ADDENDUM TO THE CONTRACT DOCUMENTS

ADDENDUM No.: 2

DATE : 8/31/15

PROJECT: New Town Hall
Construction Project
26 Court Street
Plymouth, MA

PHASE II: PLYMOUTH TOWN HALL
 PLYMOUTH, MA
FIRST FLOOR PLAN PLUMBING
 ISSUED FOR: ADDENDUM #2
 DATE ISSUED: 08/28/15
 REVISION DATE: 08/28/15

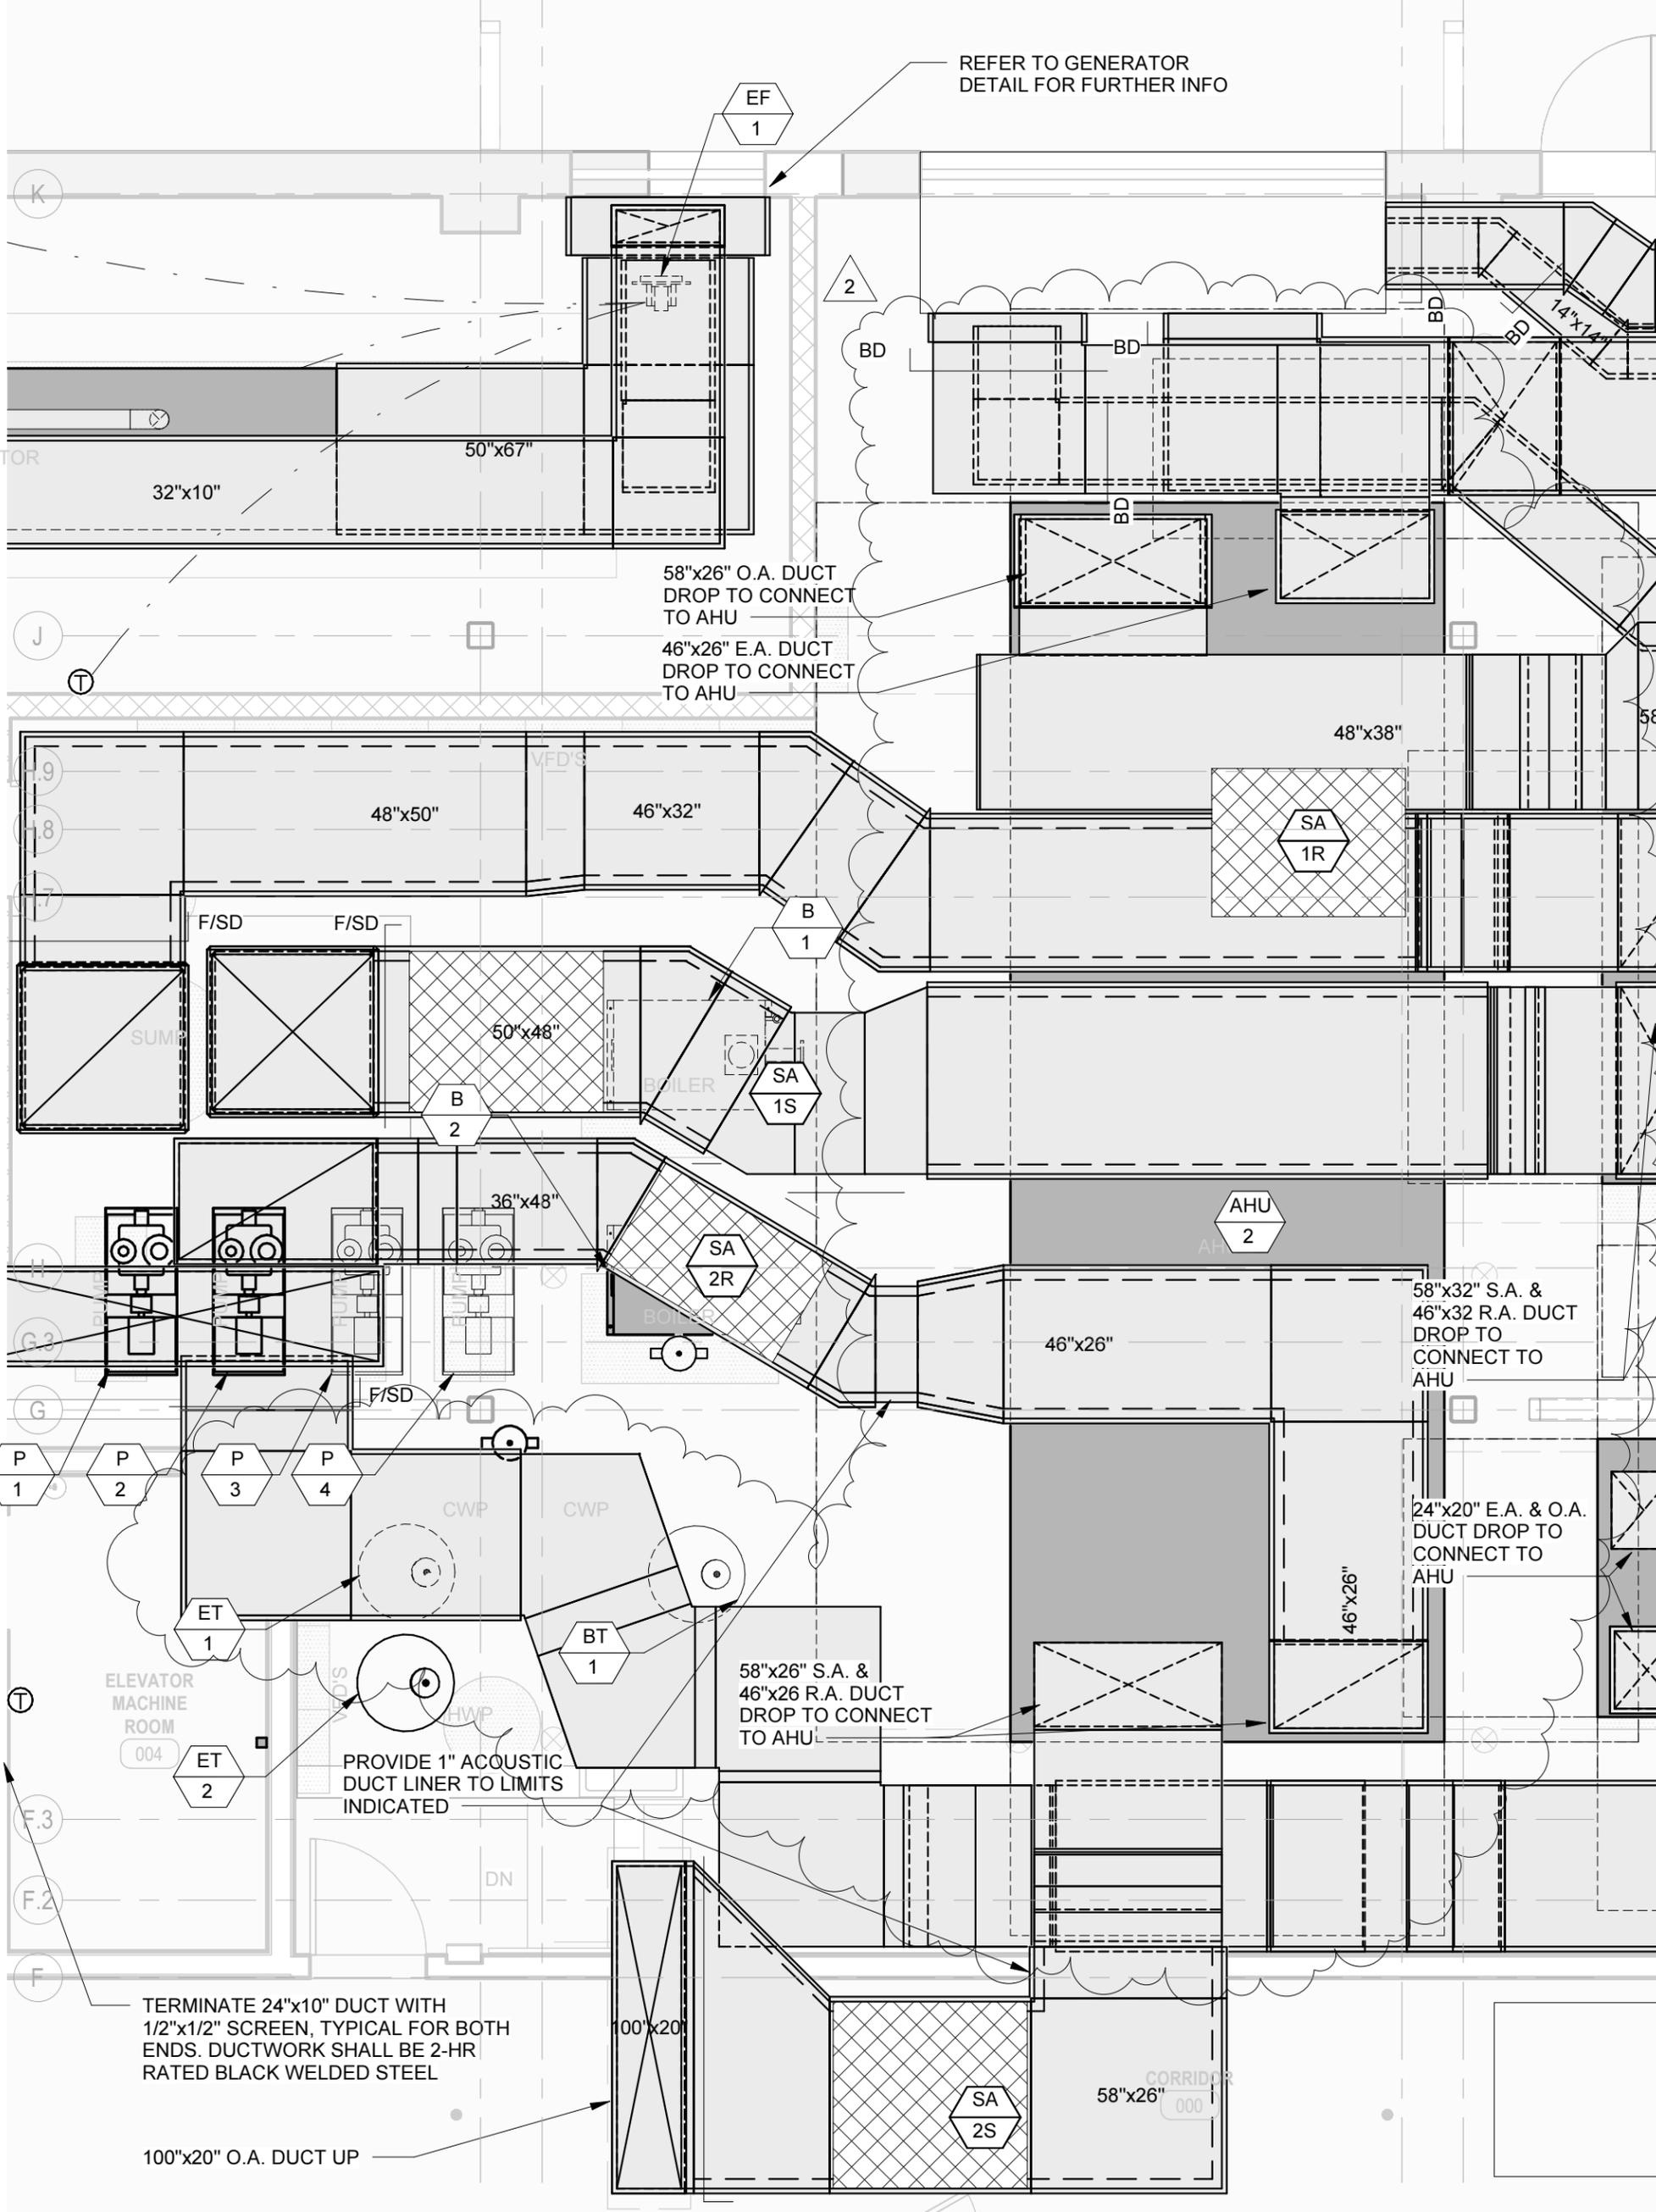
Drawing No.:	Description:
Plumbing	
P201	1. Below Slab Rain Leader piping revisions for Public Toilet Rooms; refer to sketch SKP001. 2. Rain Leader piping revisions for Public Toilet Rooms, Refer to sketch SKP002.

AHU-2 FOOTPRINT & DUCT REVISIONS

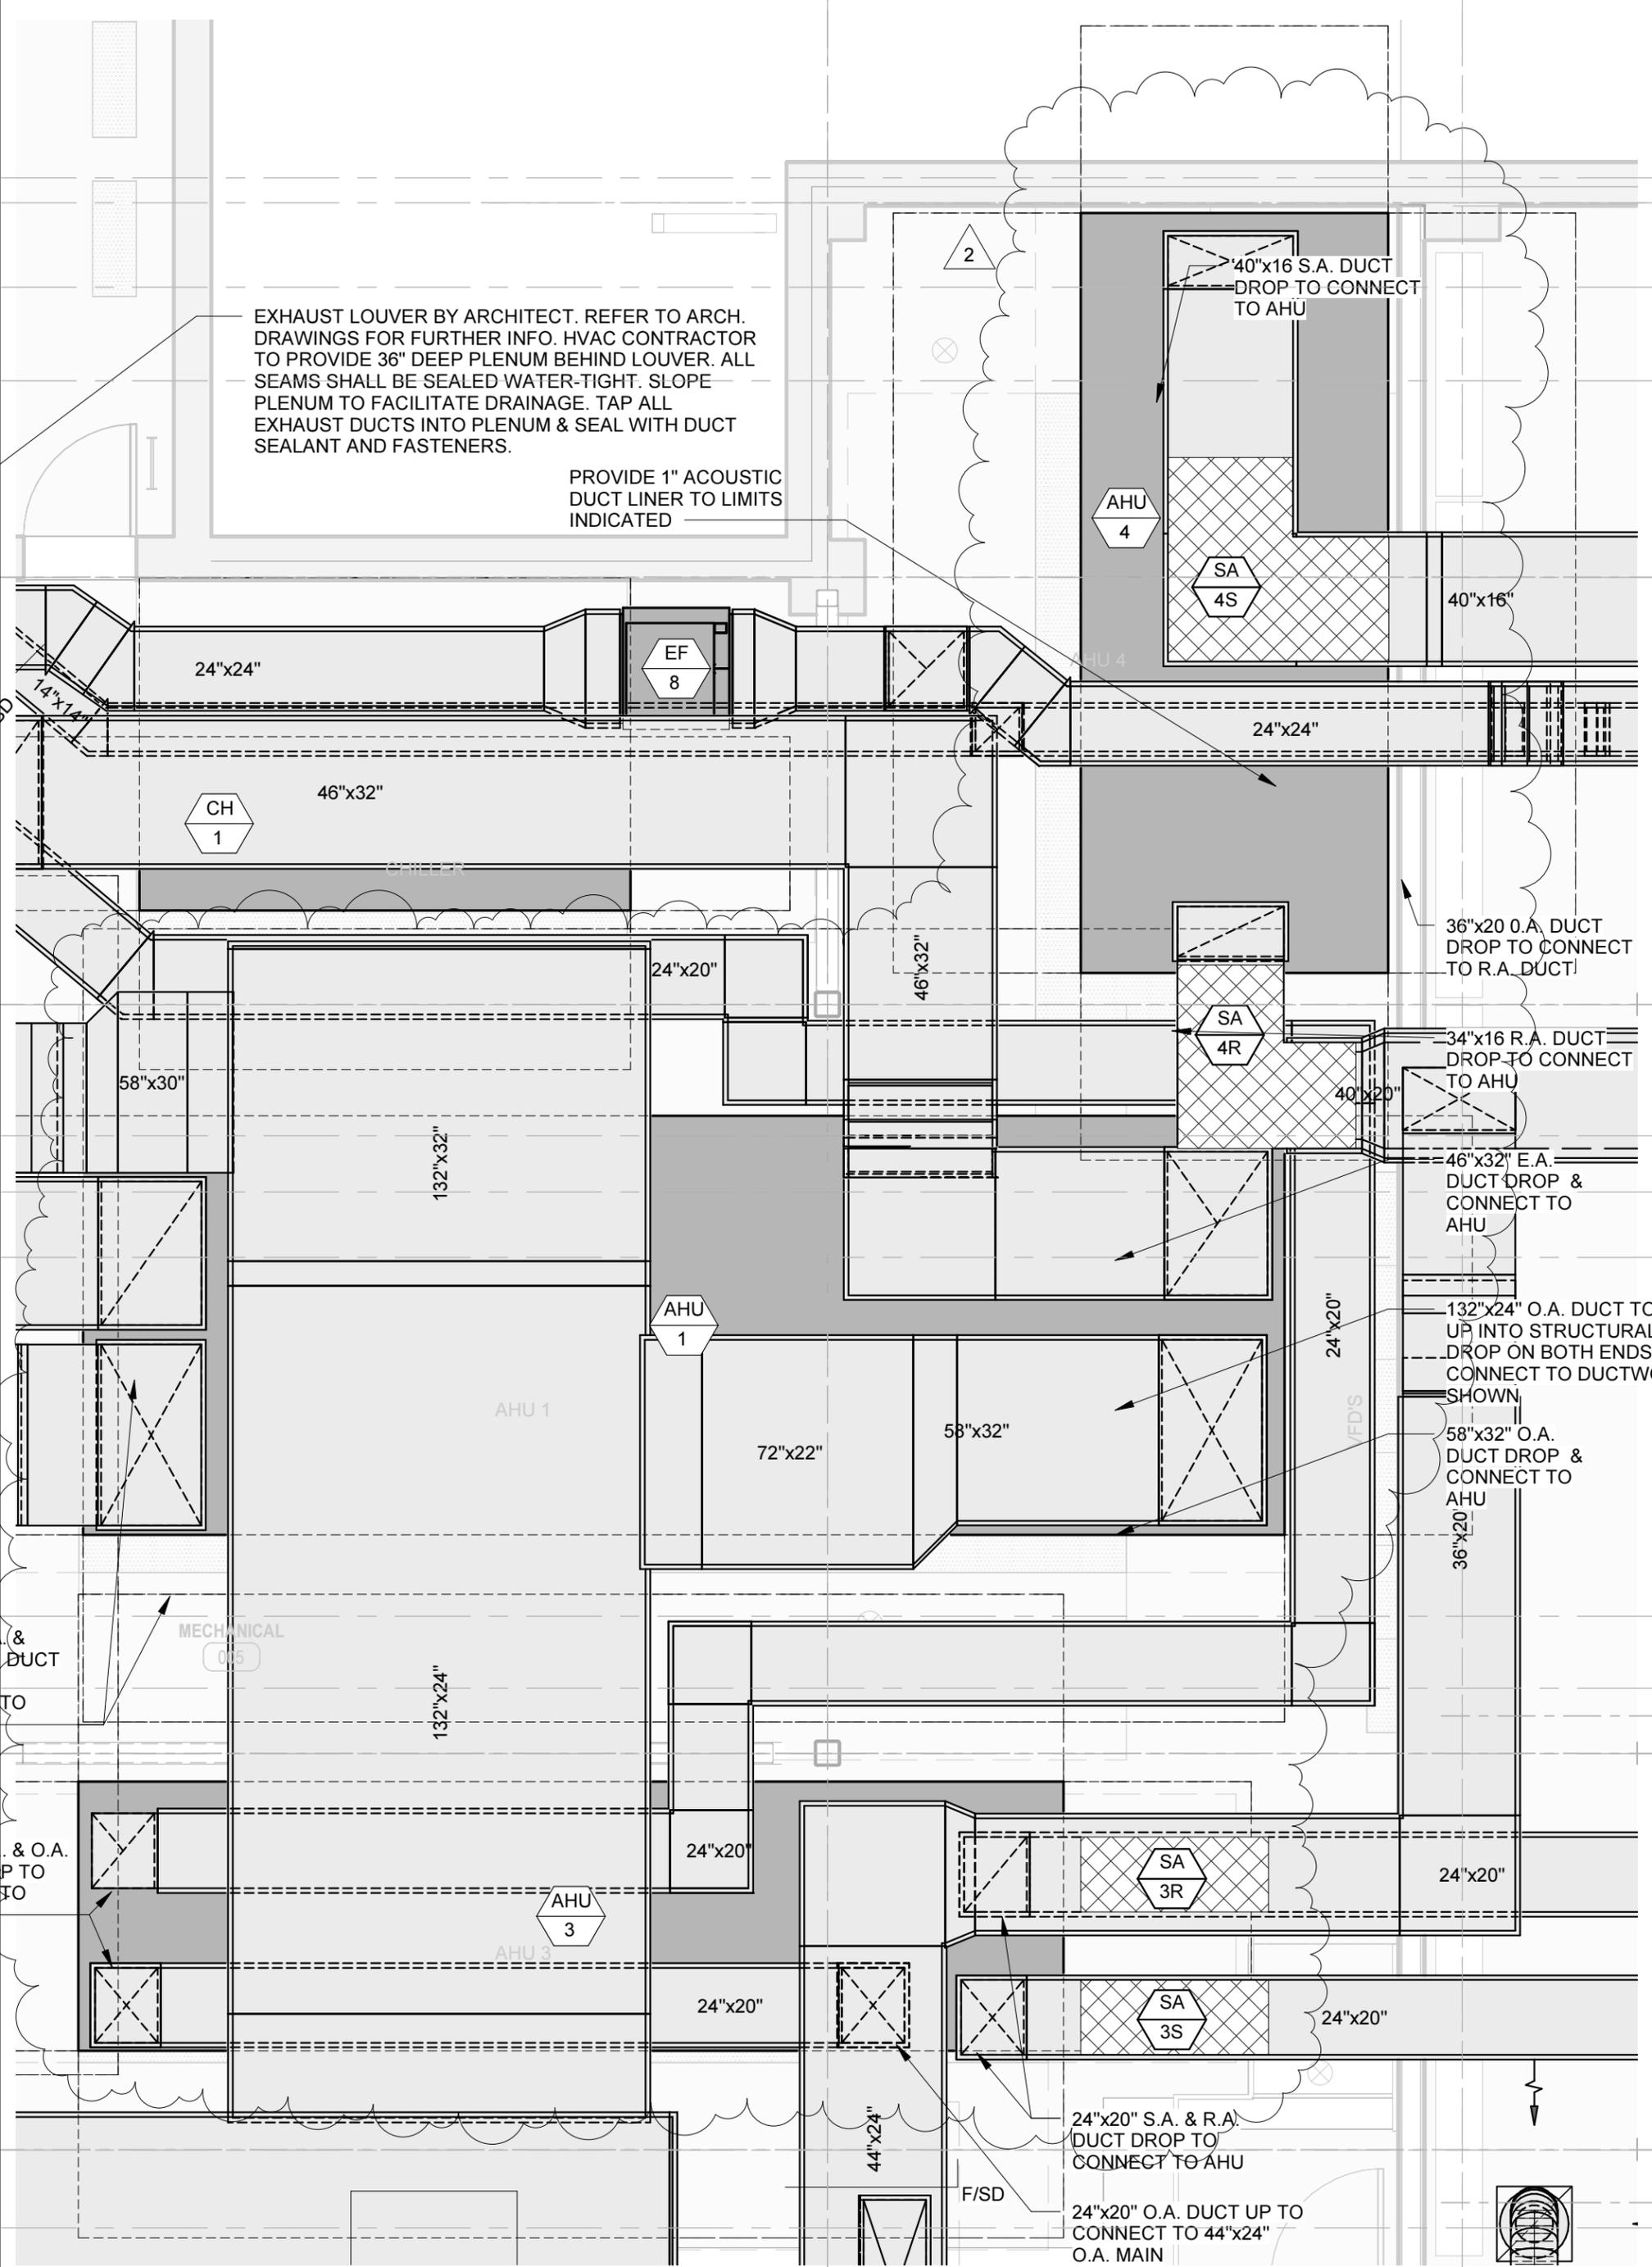
Drawing No.:	Description:
Mechanical	
M106	1. AHU-2 footprint & duct revisions, refer to sketch SKM001. 2. AHU-1, 3 & 4 footprint and duct revisions, refer to sketch SKM-002.
M206	1. DCU – Condenser pipe route revision, refer to sketch SKM003. 2. Mech. Room HHW & CHW revision (1/2), refer to sketch SKM-004. 3. Mech. Room HHW & CHW revision (2/2), refer to sketch SKM-005.
M301	AHU schedule revision, refer to sketch SKM-006.

PHASE II: PLYMOUTH TOWN HALL
PLYMOUTH, MA
POWER PLAN REVISIONS

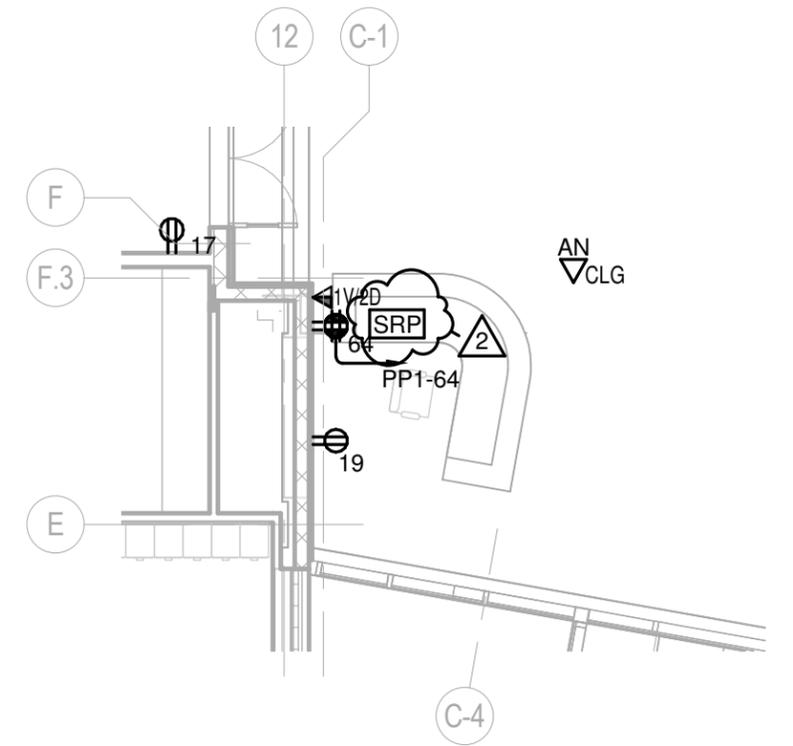
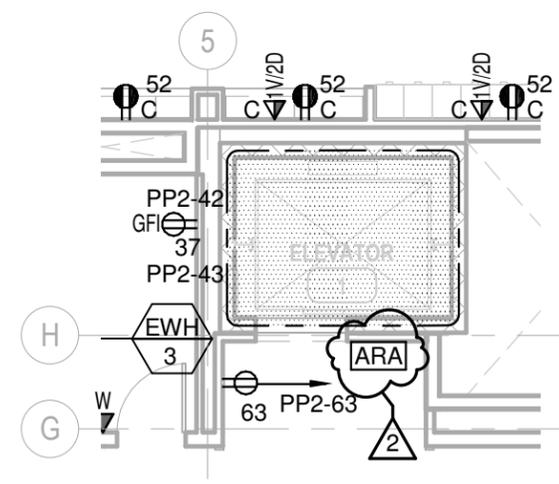
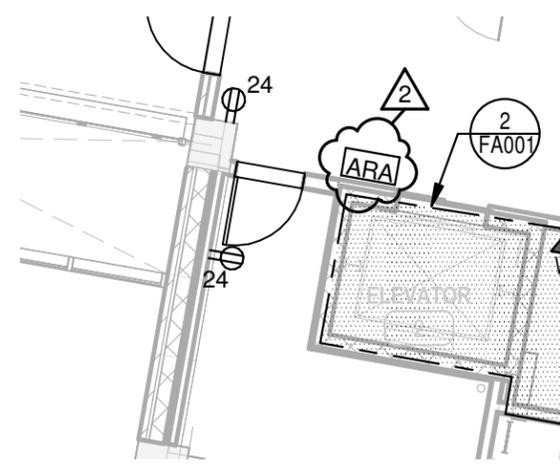
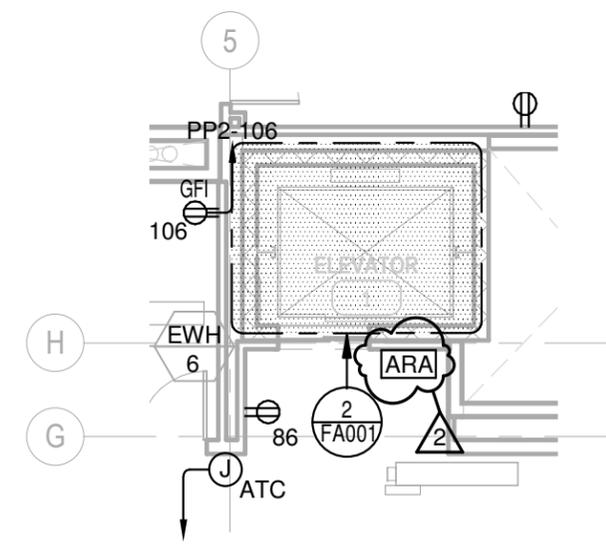
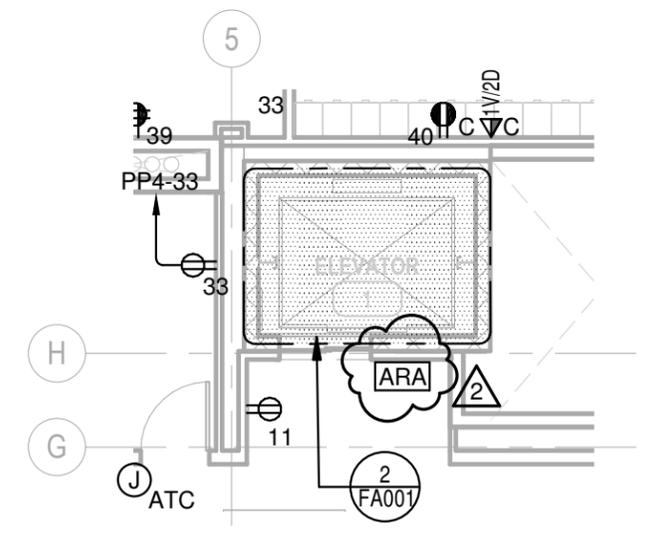
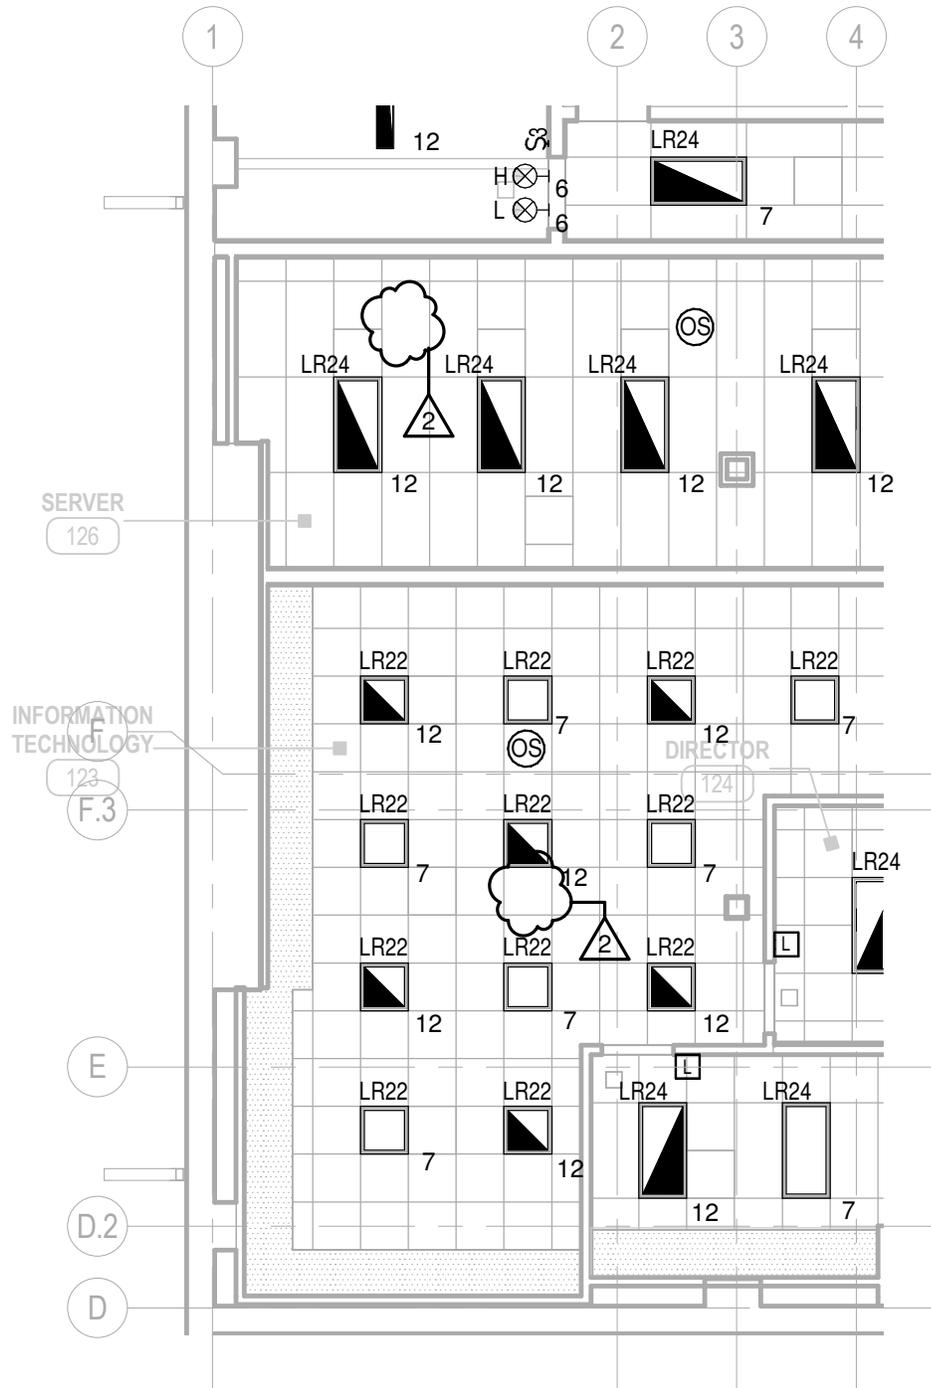
Drawing No.:	Description:
Electrical	
E001	Add "ARA" Symbols to symbol list. Refer to sketch SKE001.
E002	Revise model/series of fixtures for clarification. Replace with the revised attached sheet.
E100	Bidder Question: Fixture "LSW4" is not found on the Lighting Fixture Schedule on Plan E002. <i>Response:</i> Type "LSW4" is a typo, fixture shall be type "LS4" as shown on fixture schedule.
E101	<ol style="list-style-type: none"> 1. Revise "UC" fixture, refer to sketch SKE006. 2. Remove daylighting sensors, add occupancy sensors, refer to sketch SKE002 & SKE003. 3. Bidder Questions: <ol style="list-style-type: none"> a. In Room 133 "Facility Maintenance Office" there is a light fixture identified as LR24 but the symbol shows a 2x2 troffer fixture. b. Fixtures RC1W, LP14, and LP18, are not found on the Lighting Fixtures Schedule on Plan E002. c. In Room 114 "Copy"; There is a light fixture symbol "UC" but no light fixture to measure. Please clarify light fixture size. <p><i>Response</i></p> <ol style="list-style-type: none"> a. Fixtures in rooms 133 and 134 shall be type "LR22" in line of "LR24" shown on drawings. b. "RC1W" is on the lighting fixtures schedule, "LP18" shall be type "LP8" and "LP14" is the same as "LP8" only an A4 foot length. "LP8/" = Philips #7806LCCQG087UNVEW. "LP4" = Philips #7806LCCQ047UNVEW. c. UC fixture to be 10'-0" mounted under cabinet, circuited to LP1-7.
